PLAN SHOWING DETAILED CALCULATIONS OF AREA OF BUILDING ON PLOT NO 286 ARTILLERY MAIDAN ESTATE

PLOT NO 286 ARTILLERY MAIDAN ESTATE

BUILDING COMPLETION REPORT

Subject:- Building on Plot No: 286
on Artillery Maidan, Karachi.

PLAN SHOWING DETAILED CALCULATIONS OF AREA OF BUILDING ON PLOT NO 286 ARTILLERY MAIDAN ESTATE SCALE 2 FT. TO AN INCH.

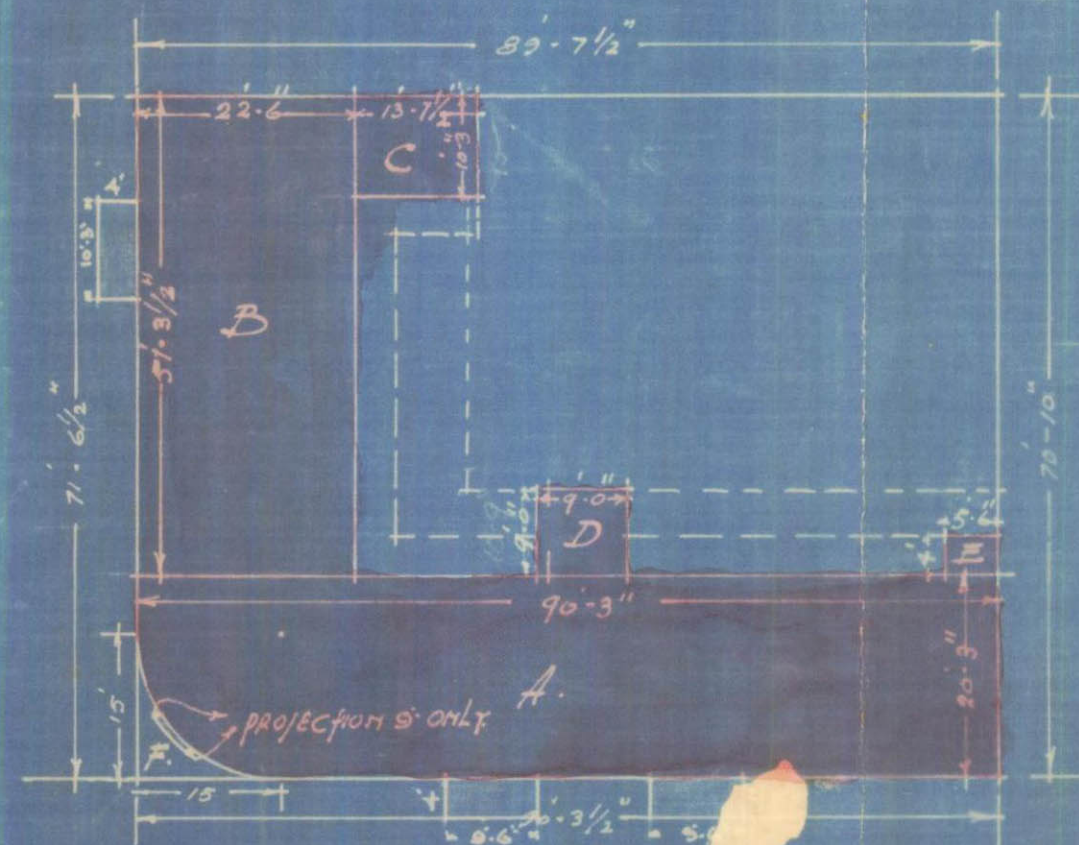
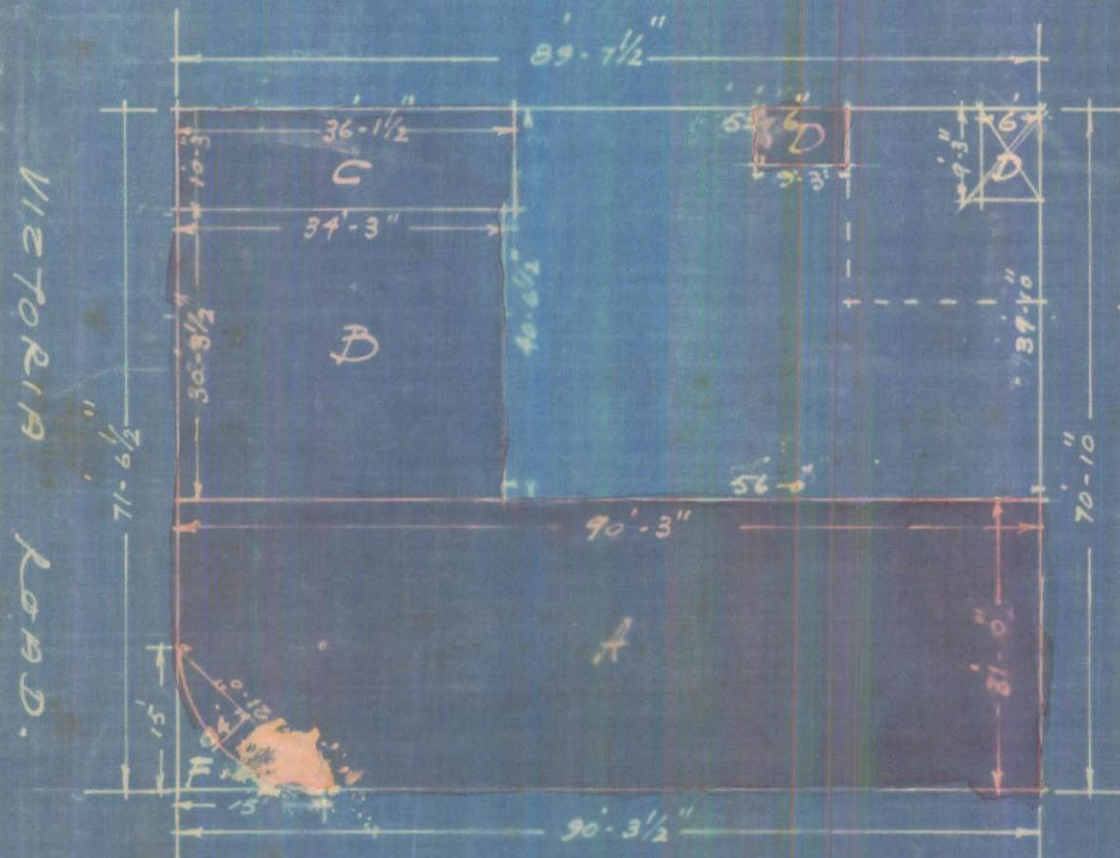
Corrected

468-1 SQ. YDS

Corrected No. 6101, dated
11/5/37

3. The covered area of the building on above mentioned plot comes to 468.1 and 352.9 sq. yds. on ground floor and upper floors respectively as per calculation sheet sent with this office No: G-31 dated 24-1-1938.

PROPOSED BUILDING ON PLOT 286 ARTILLERY MAIDAN ESTATE

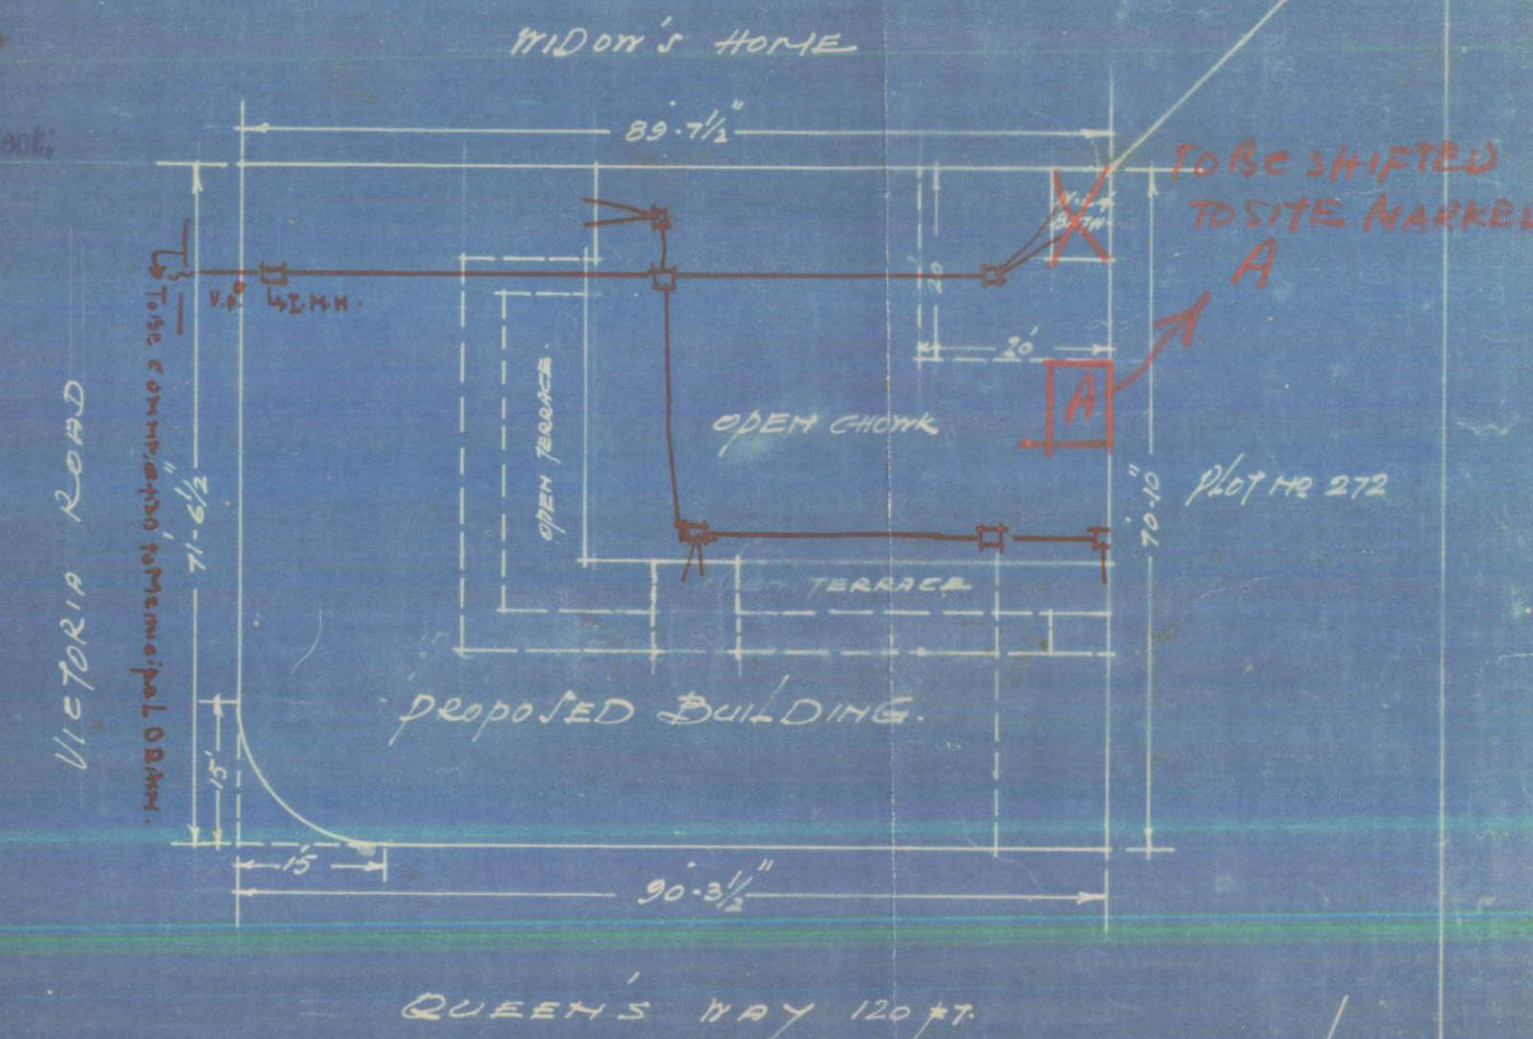
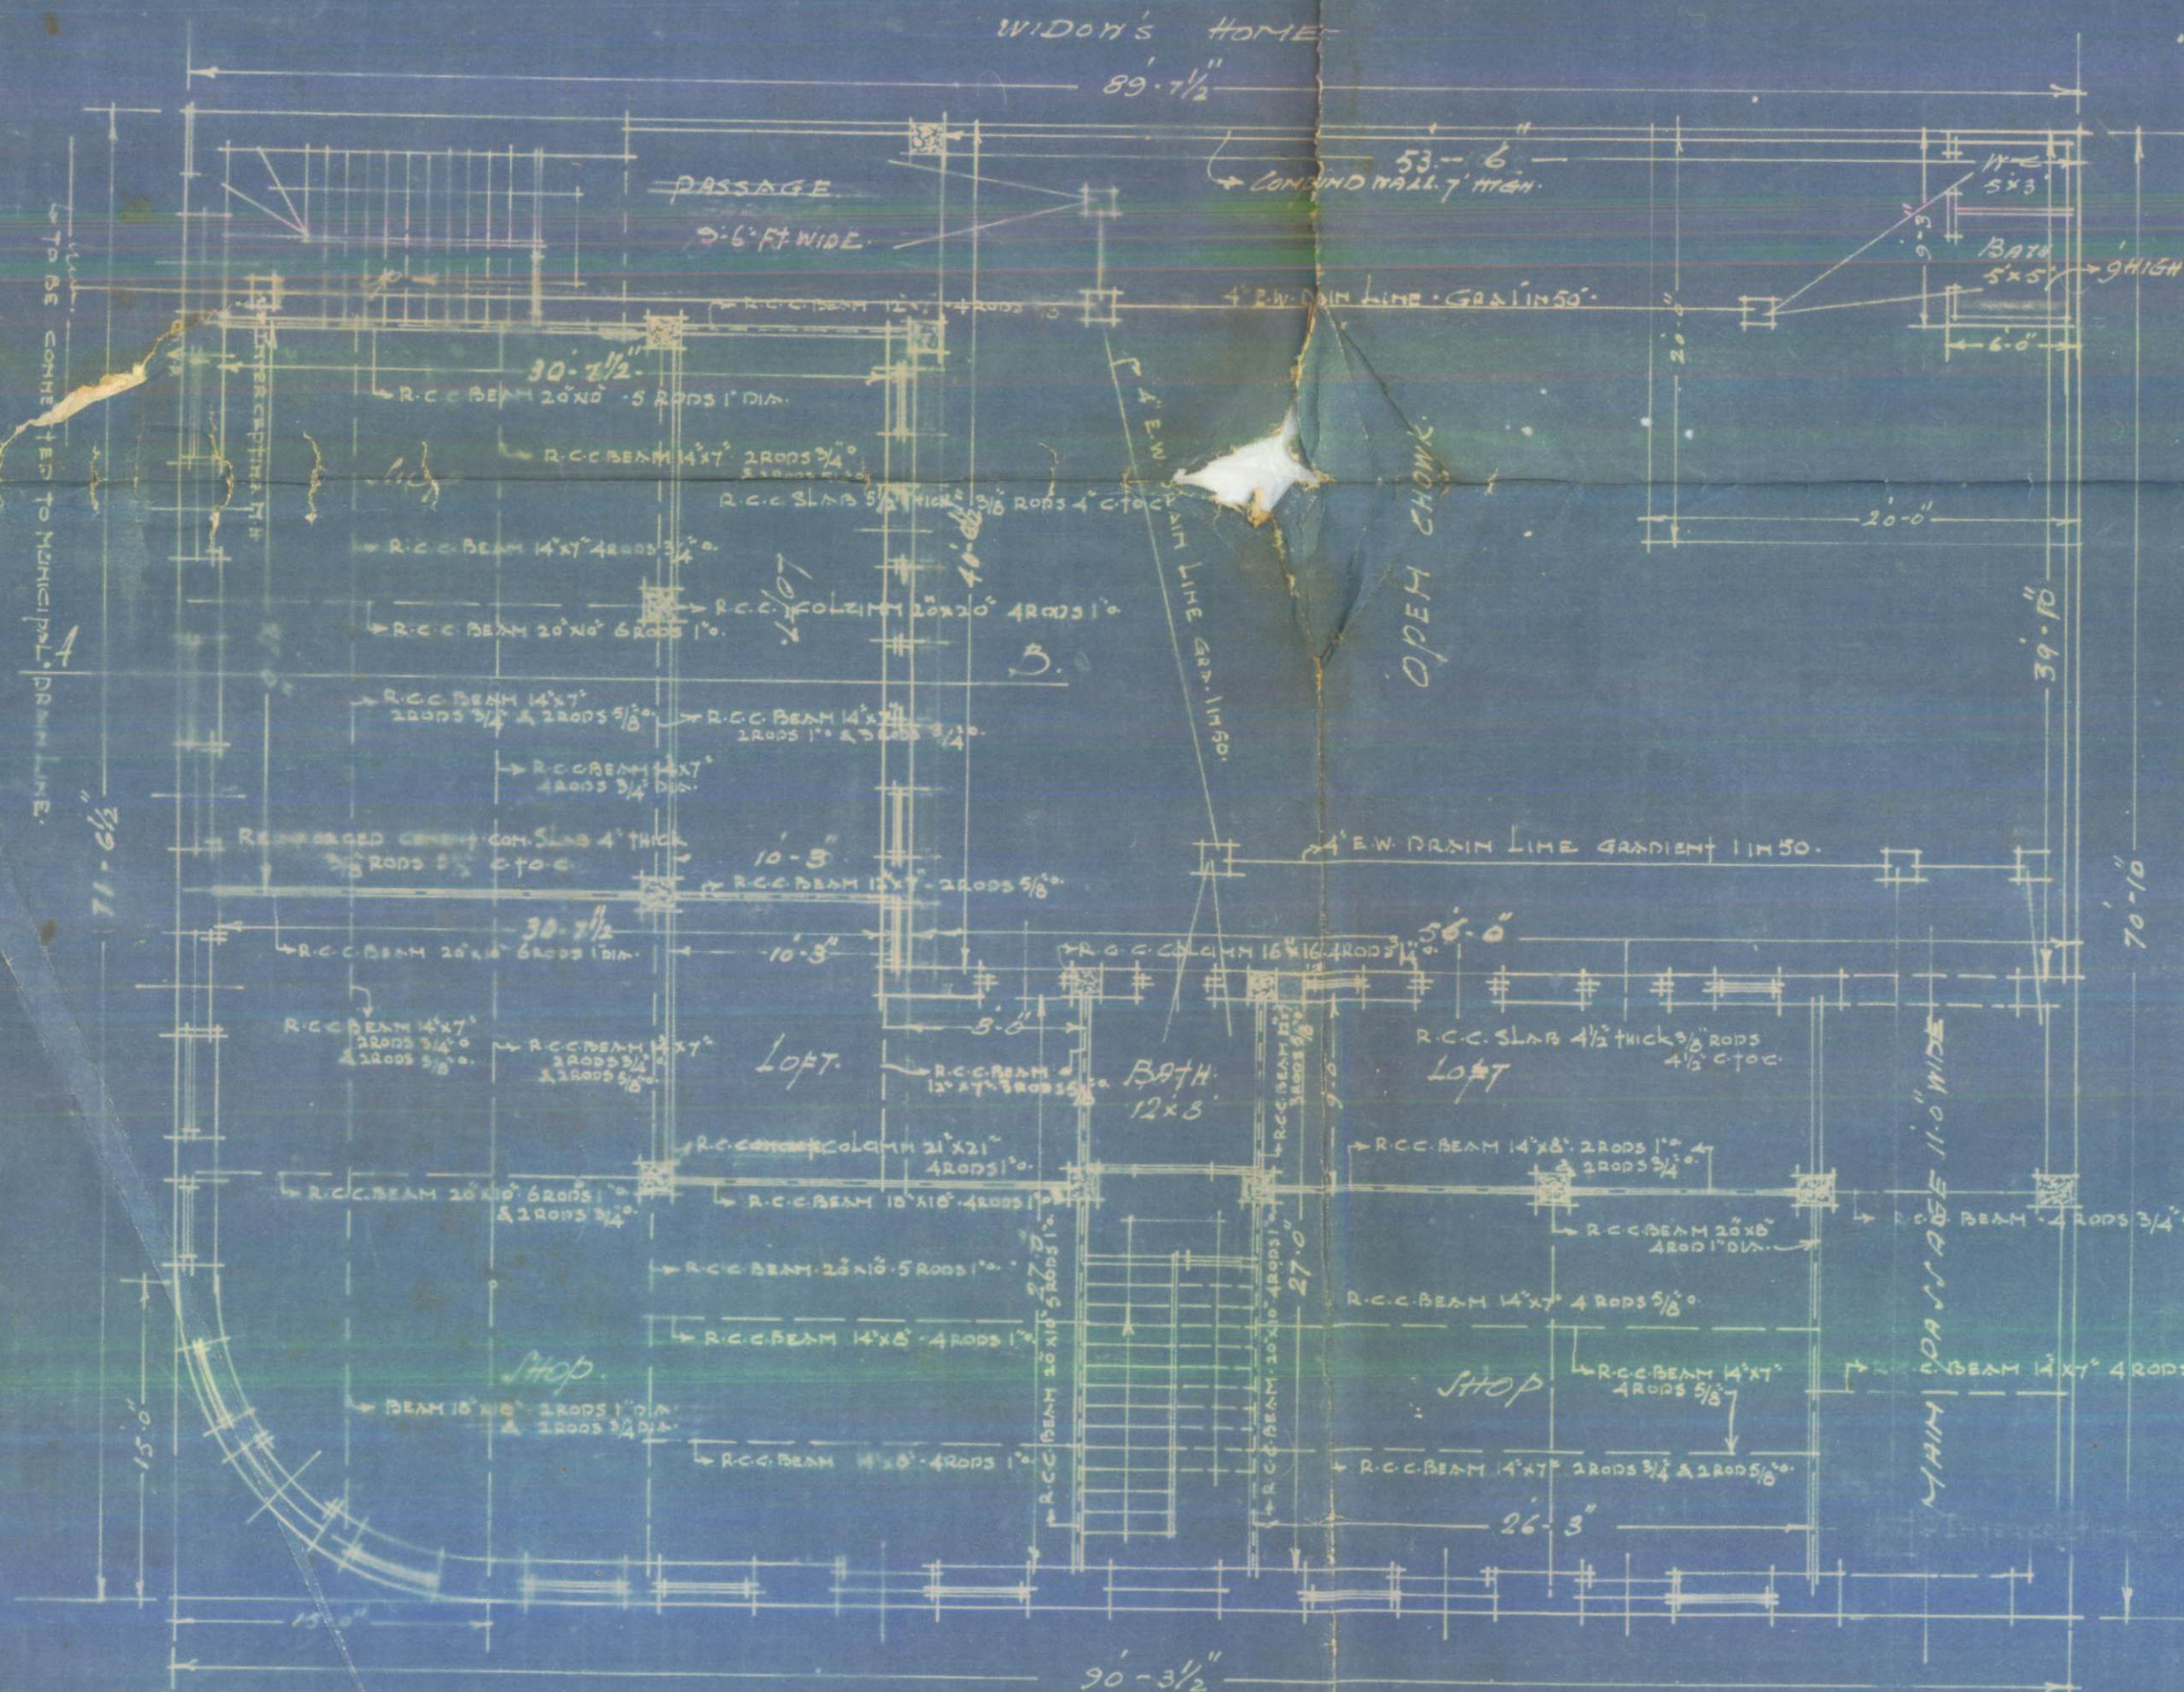
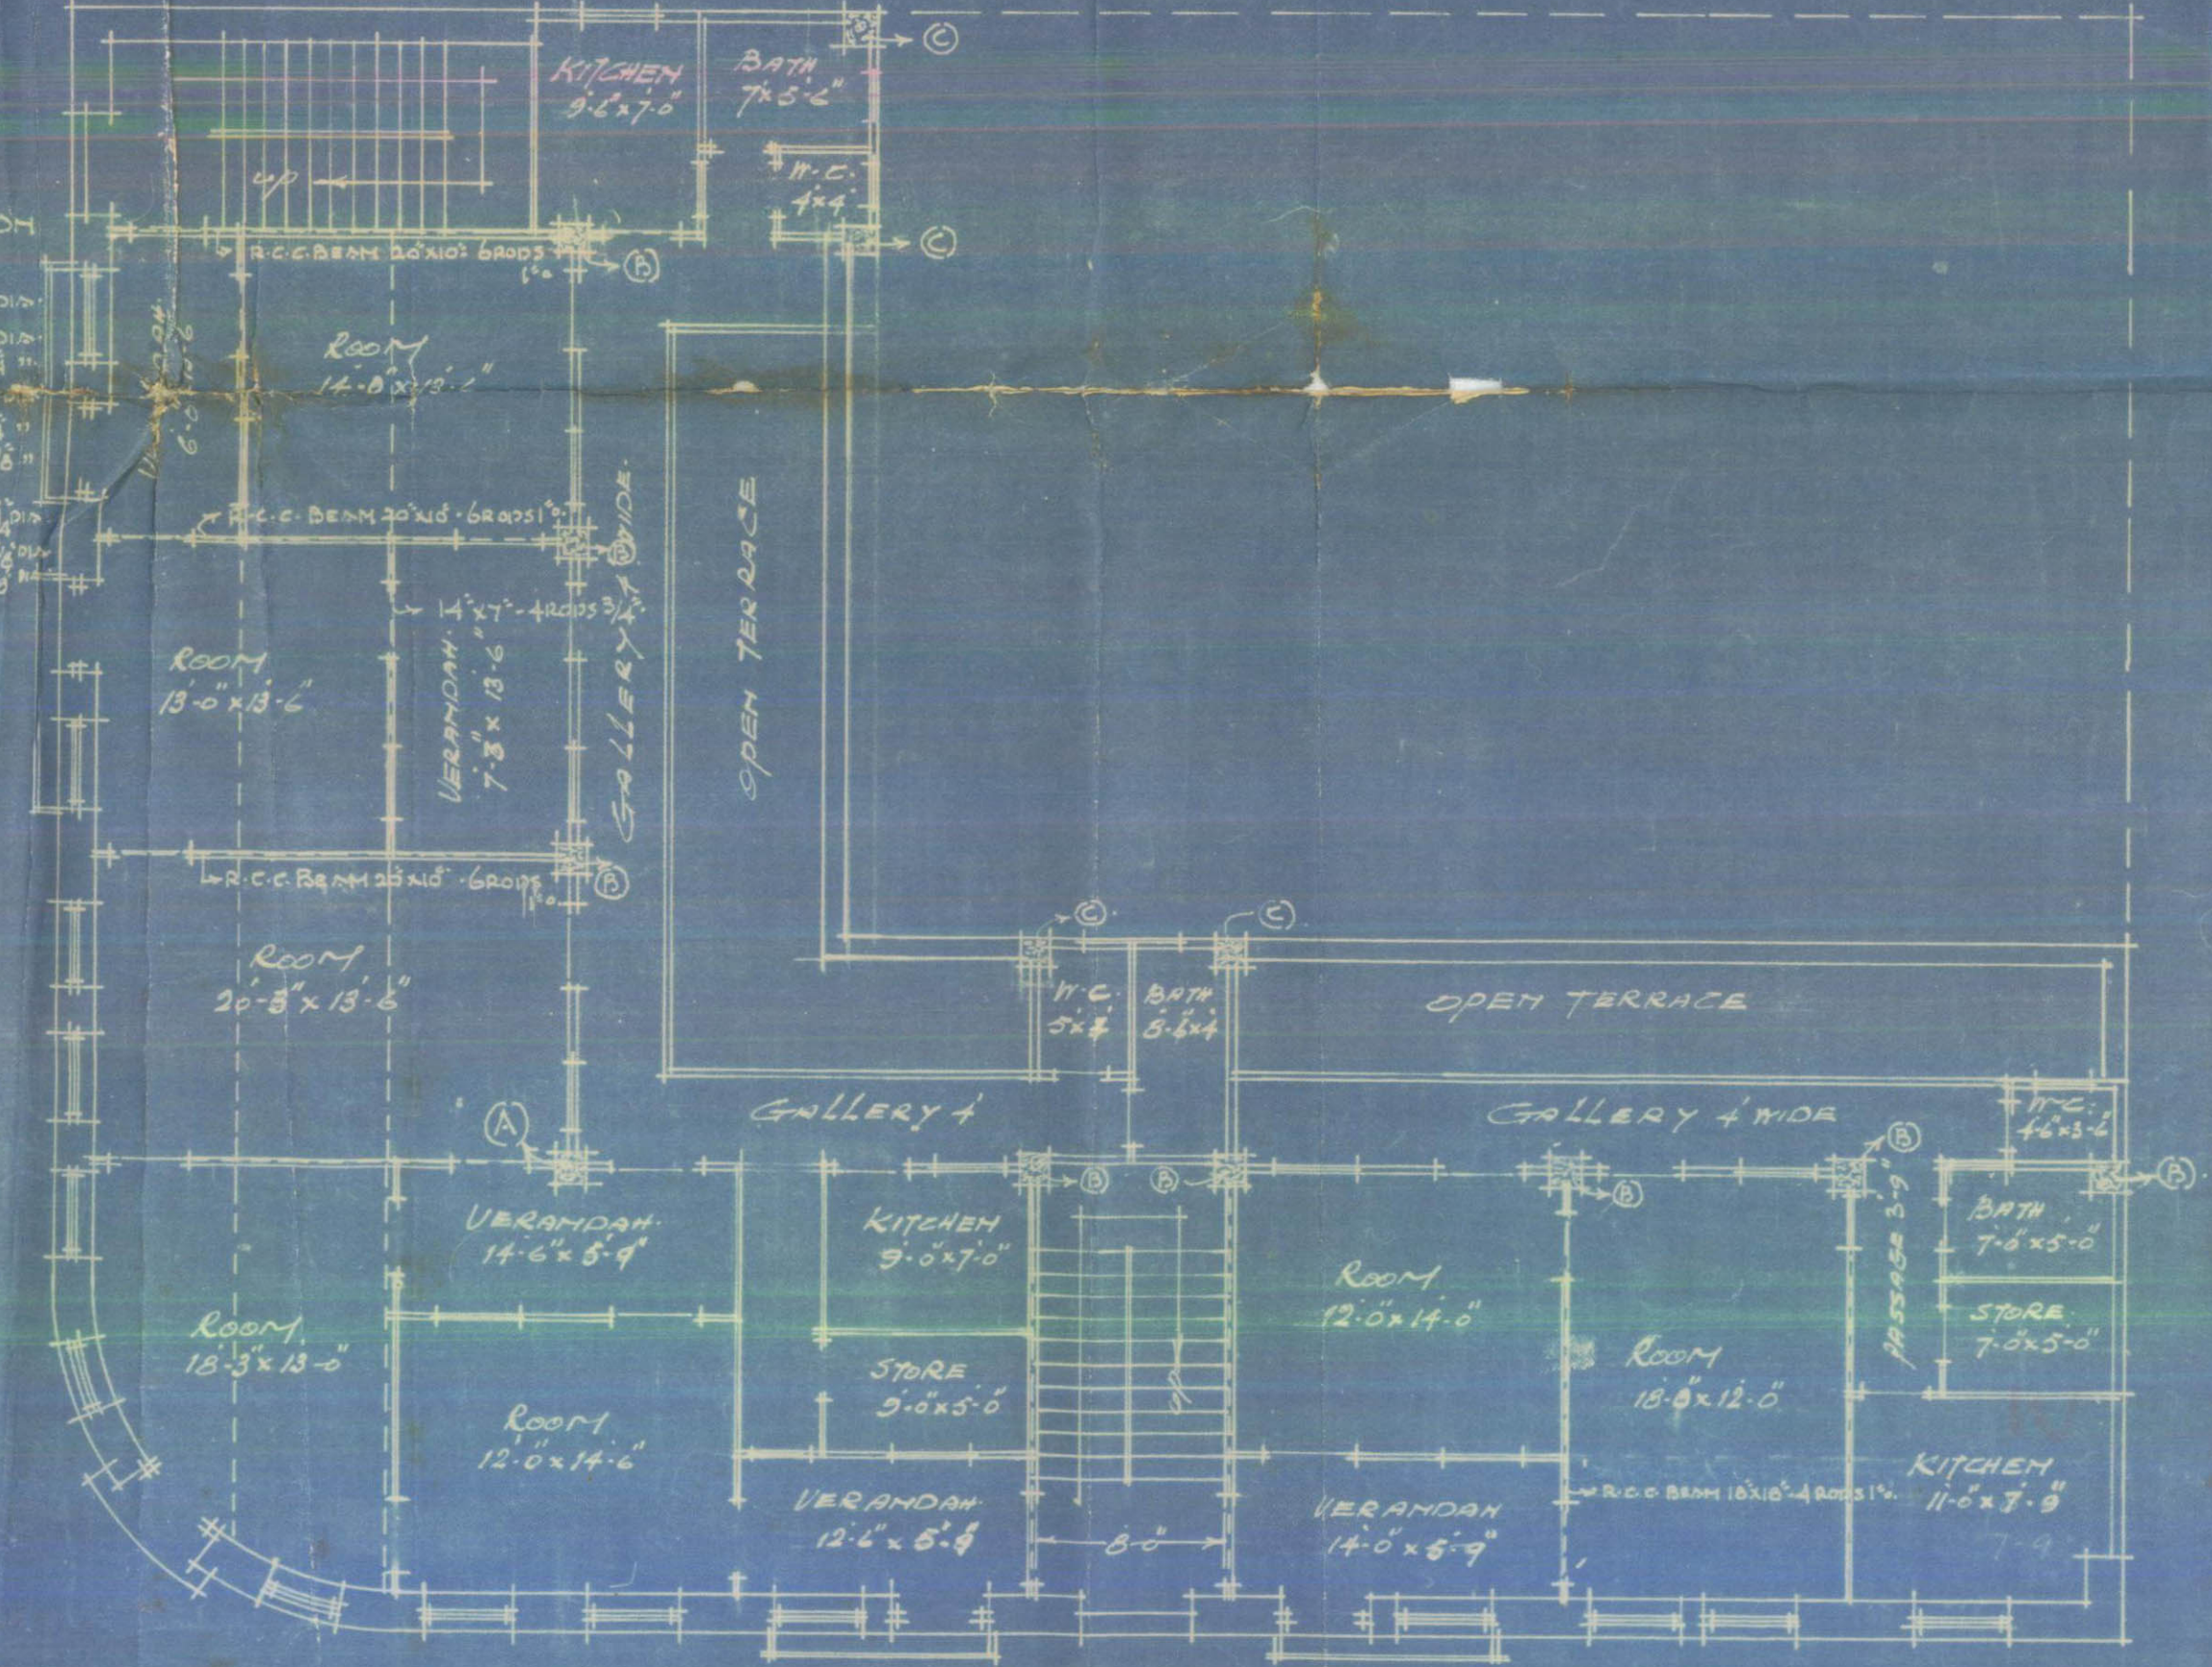
P. call the architect
in office. The
copies require
correction

2. The height of the compound wall should not exceed 4'-6" above road level.
